BROWNS FERRY NUCLEAR PLANT UNIT 1

Amendment No. 17
License No. DPR-33

SAFETY EVALUATION BY THE OFFICE OF NUCLEAR REACTOR REGULATION
SUPPORTING AMENDMENT NO. 17 TO FACILITY OPERATING LICENSE NO. DPR-33
AND AMENDMENT NO. 14 TO FACILITY OPERATING LICENSE NO. DPR-52

BROWNS FERRY NUCLEAR PLANT UNITS 1 AND 2

FIGURE 1

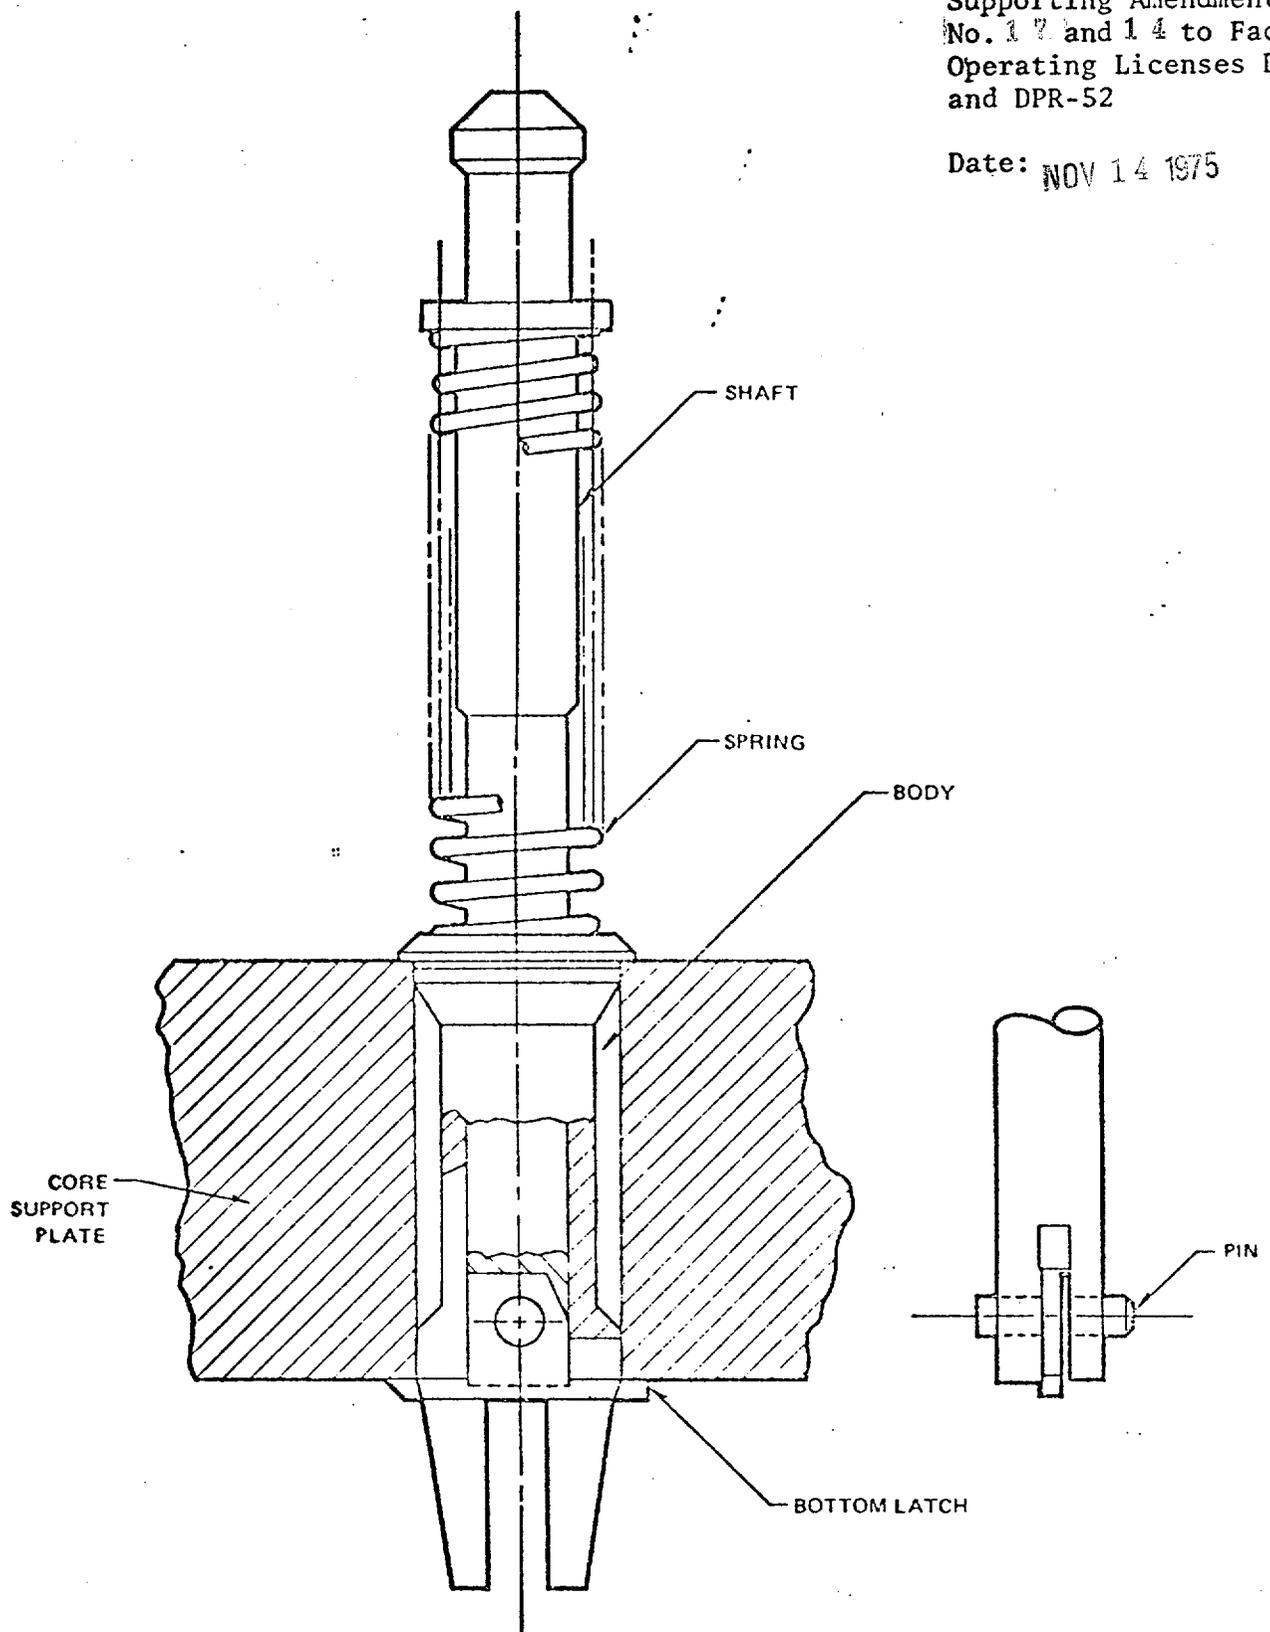
The plug consists of five basic parts, as shown in Figure 1. Identical plugs have previously been installed at Vermont Yankee, Pilgrim, Cooper, and Duane Arnold. The body provides a means of guiding the device into the bypass flow holes as well as a shoulder to support the plug and form a seal against water flow. The shaft extends through the body. A knob

is provided at the top of the shaft to provide a means of grabbing the plug during installation and extraction. At the bottom, the latch is attached to the shaft by a pin. The latch is free to rotate during installation. The spring acts against the body and shaft during normal operation to provide the force necessary to offset the pressure differential acting on the body.

During installation, the plug has its latch rotated 90 degrees from its installed position and withdrawn and locked in the body. The shaft is gripped by the installation tool, and the plug is inserted into the bypass flow holes. The body engages the rim of the hole. The shaft is pushed to its full extension, thus lowering and unlocking the latch below the underside of the core plate. The latch then rotates 90 degrees and bears on the bottom of the core plate. After insertion, the plug is pulled with about 30-pound force to test the placement. All fuel has been removed from Units 1 and 2. Therefore, the plugging operation involves no risk of fuel assembly damage and fission product release.

The plug can be removed by gripping the top of the shaft with an extracting tool and applying a force of about 500 pounds. The latch's legs will be plastically deformed and the entire plug withdrawn. The plugs previously installed at Vermont Yankee were removed with no abnormalities or loose pieces reported. The force required for removal varied from 500 to 1300 pounds.

Based on a review of the design, the installation methods and the previously successful operating experience at Vermont Yankee, Pilgrim, and Duane Arnold, we conclude that the plugs can be installed without damage to core components, that they will not fail during operation so as to result in loose parts in the core or result in unplugging of the bypass flow holes, and that they can be removed, if necessary, without damage to core components. The modification is thus reversible.

Accordingly, we conclude that the installation of the plugs is acceptable. The present license amendments, which authorize plugging of the core lower support plate bypass holes, do not authorize operation of the facility with these holes plugged. Such operation is not presently intended by the licensee and would be the subject of a separate licensing action if such operation is proposed. It is presently TVA's intention to complete the drilling modification, subsequent to our approval, prior to return to operation. This modification also will be the subject of a separate licensing action.
